Office Action Summary

10/613,172

WILKIE, GEOFFREY D.M.

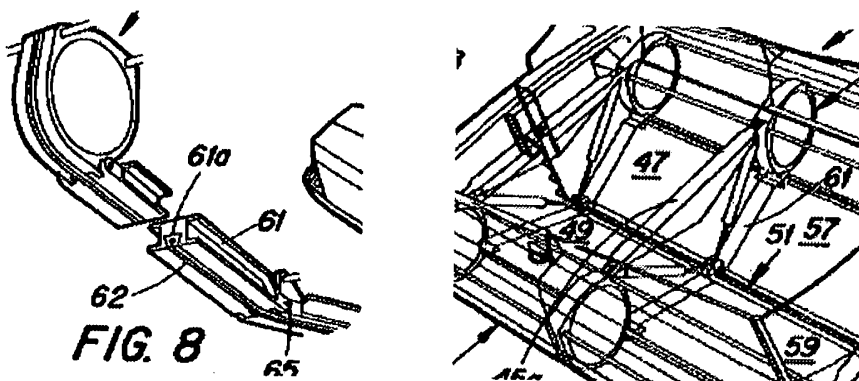
9. Claims 8 and 22 would be allowable if:

- the rejection(s) under 35 U.S.C. 112, first paragraph, set forth in this Office action are overcome, and .

- the claims are rewritten to include all of the limitations of the base claim and any intervening claims.

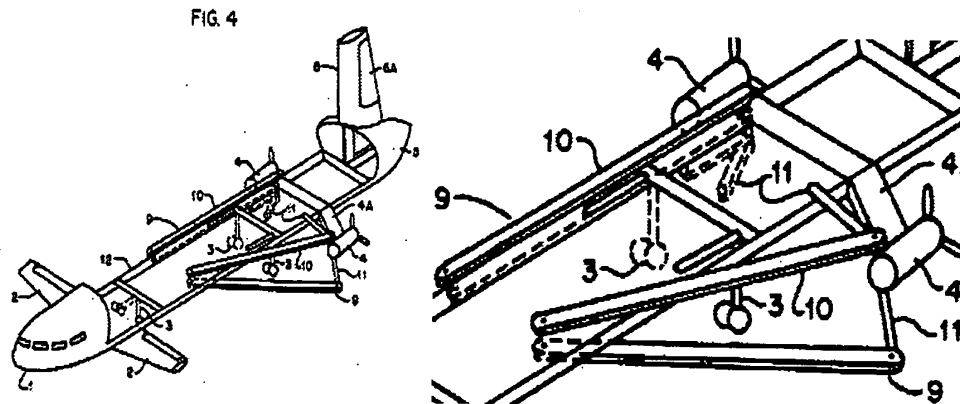
102(e) rejection based on Syfritt: The applicant has referred to figures 11a-11c, and argued that Syfritt does not show a truss assembly.

Examiners Answer: The Examiner has applied the embodiment shown in figures 7-10, and not figures 11a-11c. The arrangement of tie members 61 is considered equivalent to a truss assembly (see col. 9, lines 34-35; and the figures below).
